Re: Helix Micro Rebar Shop Drawings
1713 SW Merryman Dr
Lot 48, The Manor
Lee's Summit Permit #2018-1745

Apex Engineers, Inc. observed the plans for the proposed house at the address referenced above. The plans were evaluated for substituting Helix micro rebar for the foundation reinforcing steel. The recommendations and attached detail sheets shall be considered shop drawings for an alternative reinforcement design.

ALTERNATE REINFORCEMENT DESIGN/HELIX MICRO REBAR

2
H1.0
1/2" = 1'-0"

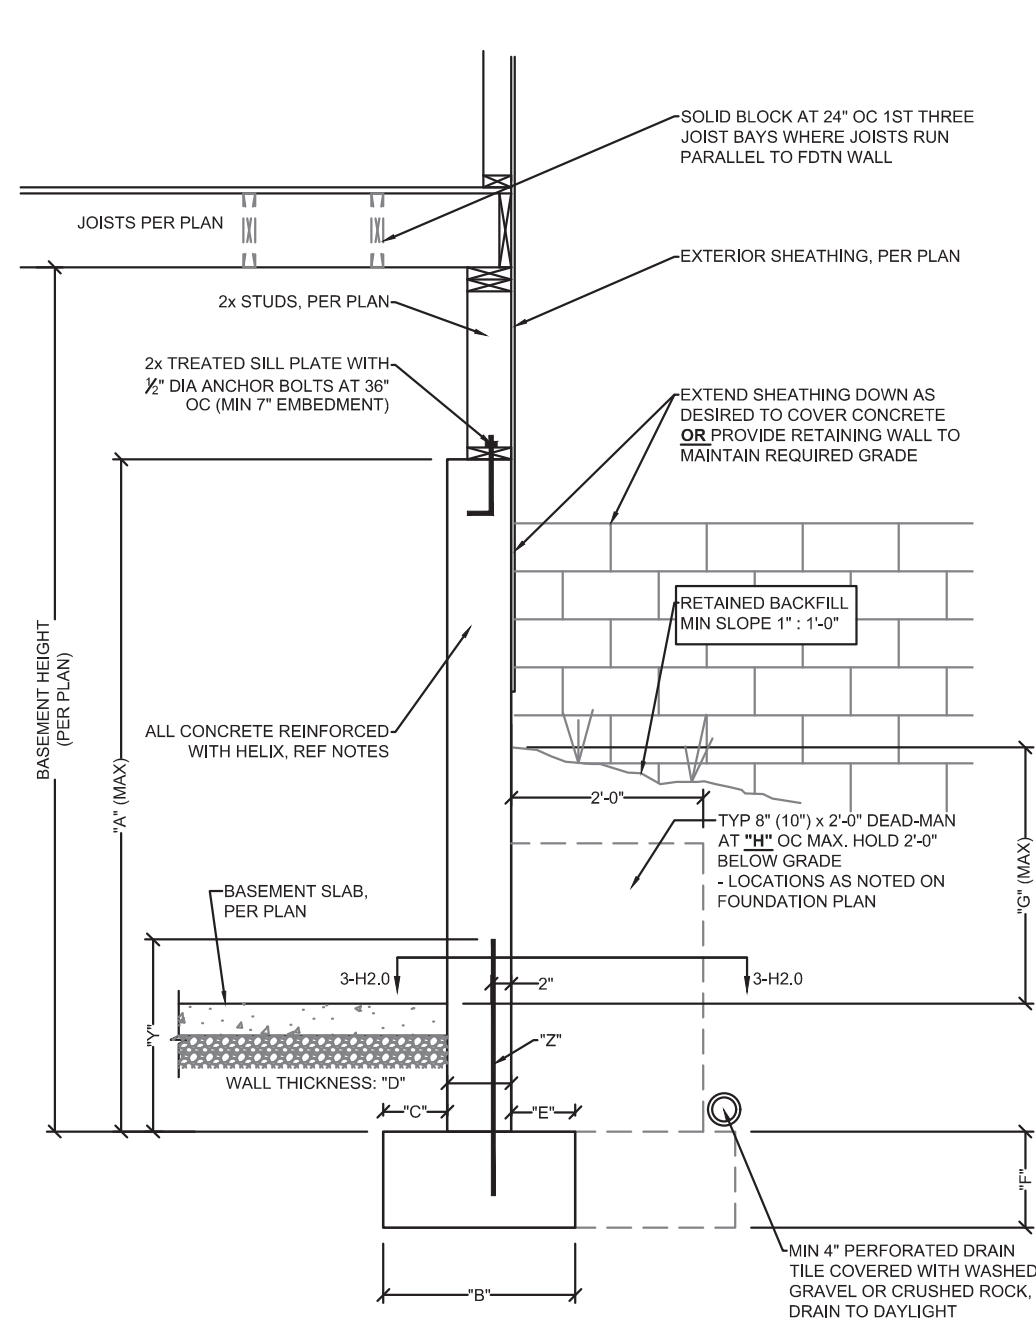
- Detail 2/H1.0 - Daylight foundation walls are concrete walls not directly connected to the floor joists via the sill plate. Daylight foundation walls shall comply with the following layout restrictions:

- Daylight walls greater than 4'-0" tall shall be bookended by corners, offsets greater than 2'-0", and/or return walls at a maximum spacing of 16'-0" on center. Return walls shall be placed per 3/H2.0

- Daylight walls greater than 6'-0" tall shall not exceed 6'-0" in length.
 - Daylight walls 4'-0" tall and less do not require return walls.
- Detail 3/H2.0 – Return walls shall be installed per plan. Additional return walls may be required to comply with the specifications above.

1
H1.0
1/2" = 1'-0"

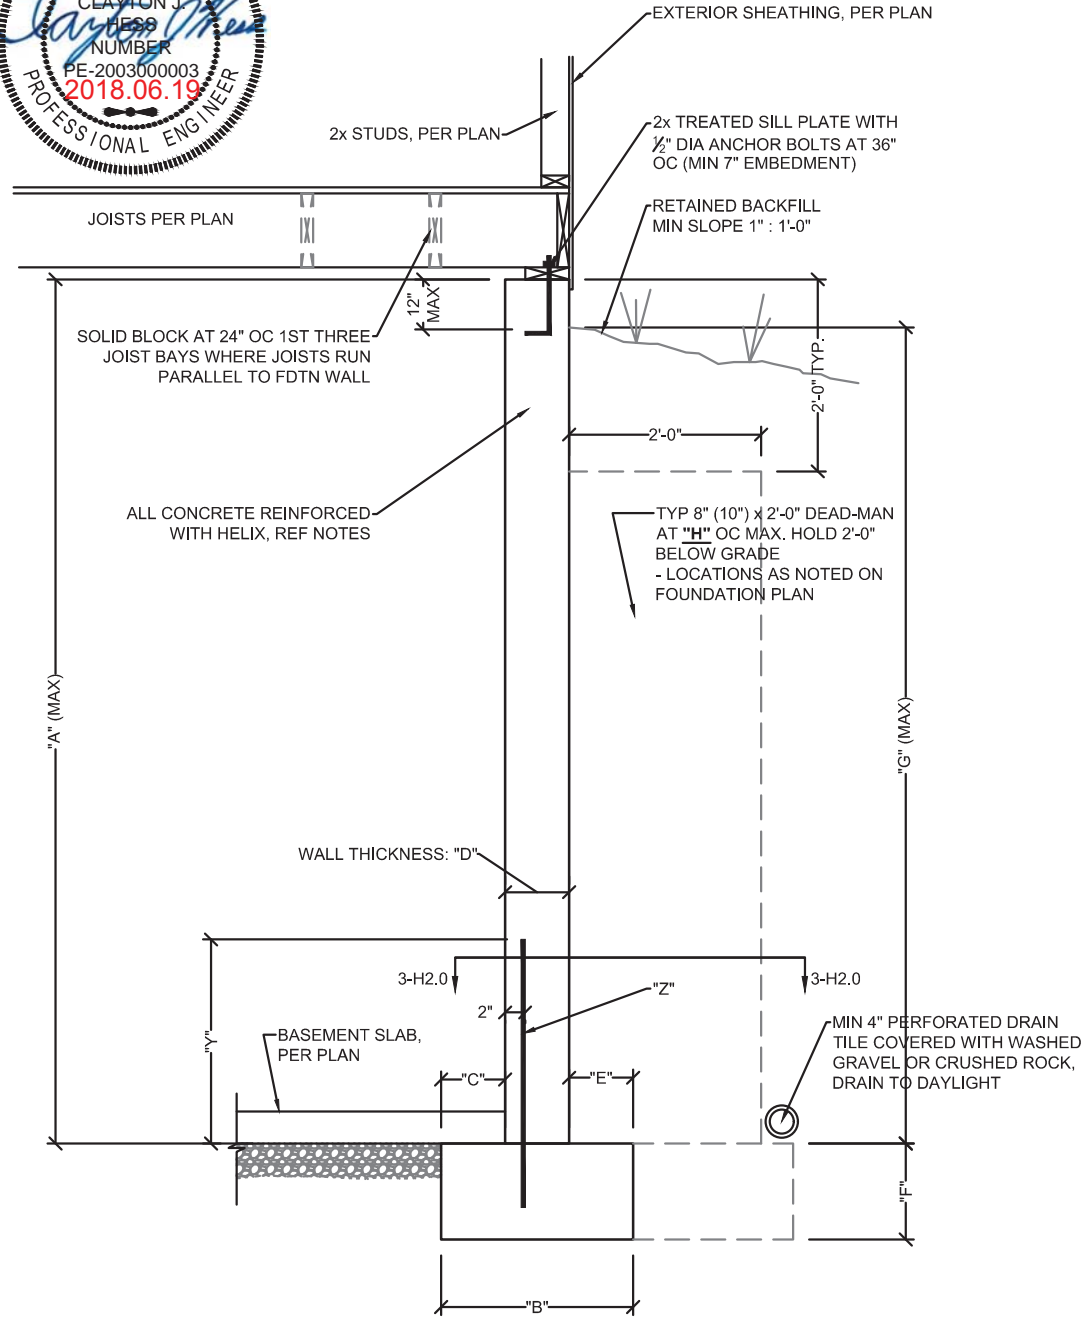
- Detail 1/H1.0 - Foundation walls, once completed, shall be laterally braced at the top by the first floor deck and at the bottom by the basement slab.

5 COLUMN PAD DETAIL
H2.0 1/2" = 1'-0"

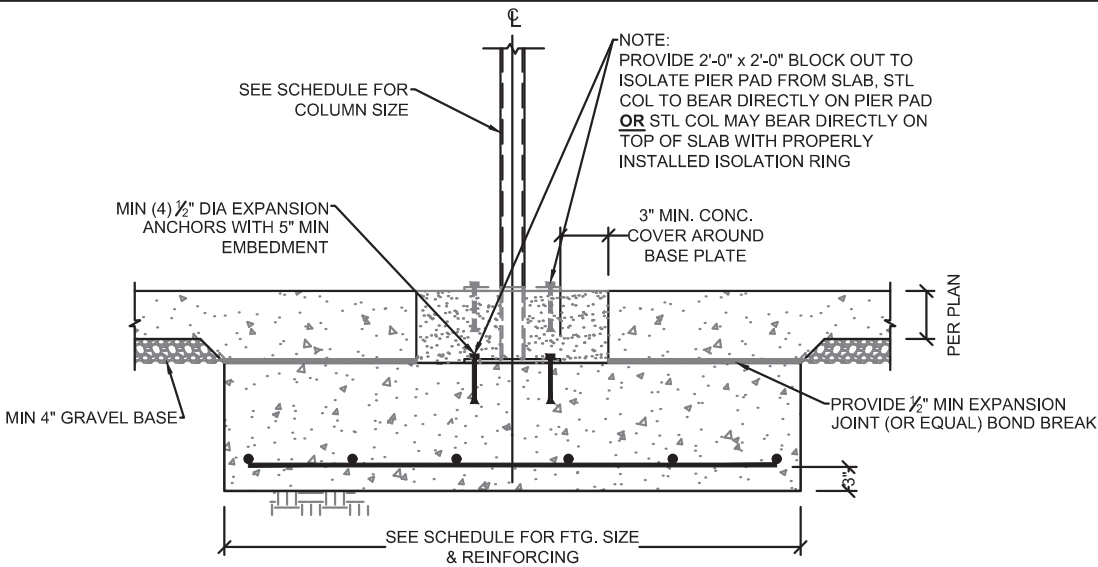
- Details 4/H2.0 & 5/H2.0 – Install corner reinforcing and column pads reinforcing per the attached details.
